**Re: Revised Ecology Contingent Approval Letter for the Indoor Air Sampling and Analysis Plan (SAP) for the McKinstry Building located at 5005 3<sup>rd</sup> Ave. South, Seattle, Washington, dated December 21, 2018**

Attachment A: Ecology Comments, Clarifications, and Required Modifications for the  
Contingently Approved Indoor Air Sampling and Analysis Plan (SAP)

**Attachment A:** Ecology Comments, Clarifications, and Required Modifications for the Contingently Approved Indoor Air Sampling and Analysis Plan (SAP) for the McKinstry Building Located at 5005 3<sup>rd</sup> Avenue South, Seattle, Washington, dated December 21, 2018

**AECOM**  
**Figure: 3**

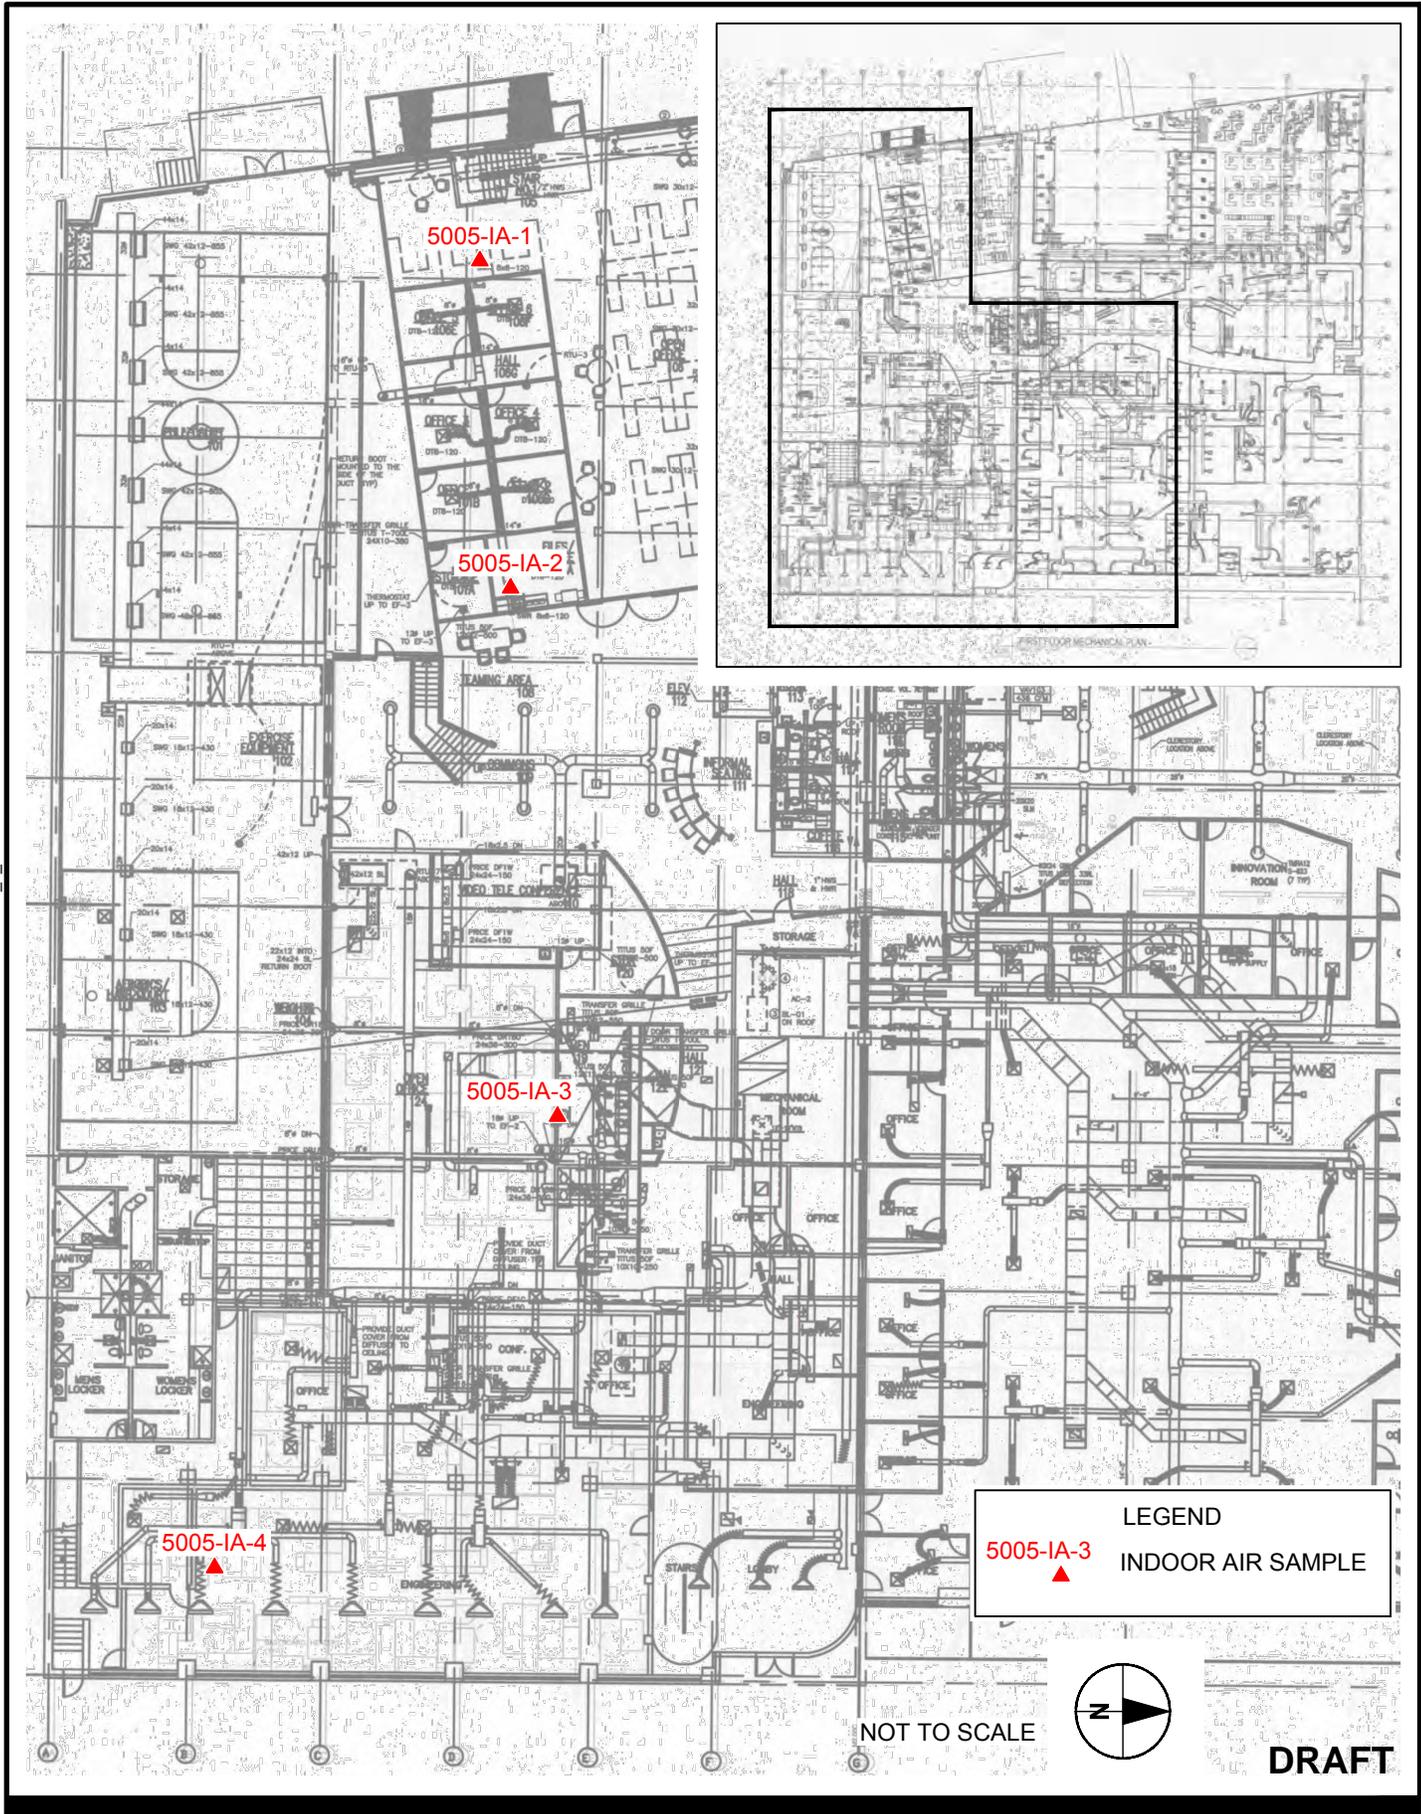
3. Section 2.3 Air Sampling Methods and Procedures: Indoor air samples 5005-IA-2 and 5005-IA-4 shall be collected in the enclosed offices as stated during our December 19, 2018 telcon meeting, noted in Figure 3, and as observed and noted during the pre-indoor air sampling building site visit on November 24, 2018. This is Ecology's preference for these sample locations as they are in enclosed offices occupied by staff most of the workday. Since indoor air sampling will occur on a weekend when the offices will presumably be unoccupied, Ecology cannot see any obvious reasons to potentially replace an enclosed office sample location with a conference room as noted in the SAP text. Ecology recommends a short walk through the area of the building a day prior to when indoor air sampling is planned in order to verify indoor air sample locations and remove any chemicals that may potentially interfere with the TO-15 chemical analysis. Please refer to paragraph 10 below for any field modifications to sampling locations. Ecology has requested that GE/AECOM also indicate if women are present in those indoor air sampling locations (Figure 3) during work days and can include this information in the indoor air monitoring report.

5. Section 2.3 Air Sampling Methods and Procedures: GE shall include at least one field duplicate sample in one of the enclosed offices (Figure 2).
6. Section 2.3 Air Sampling Methods and Procedures: GE shall record the wind direction before and during indoor (and ambient) air sampling.
